INFORMATION TO BIDDERS

DOWNTOWN LIBRARY SELECTIVE CLADDING REPLACEMENT Contract No. BE20-235

City and Borough of Juneau
ENGINEERING DEPARTMENT
155 South Seward Street
Juneau, Alaska 99801

Date Issued: May 19, 2020

Figure 3: Rot at Bottom of Panel

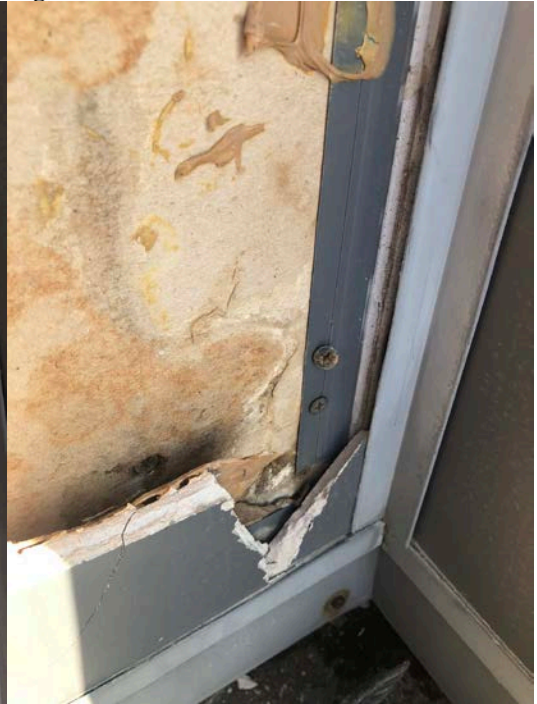
The gypsum sheathing showed evidence of water infiltration the full extent, with pockets of significant degradation around the window, see **Figures 2-8**.

Water is infiltrating the entire wall system at the panel clips due to sealant degradation over time. Without a water repellent material behind the exterior panels to create a drainage plane – the water is collecting and saturating the gypsum sheathing. Through freeze/thaw the collected water is cracking the exterior panels. While the windows are probably (?) sealed to the gypsum, the lack of a barrier lap is allowing water into the interior cavity.
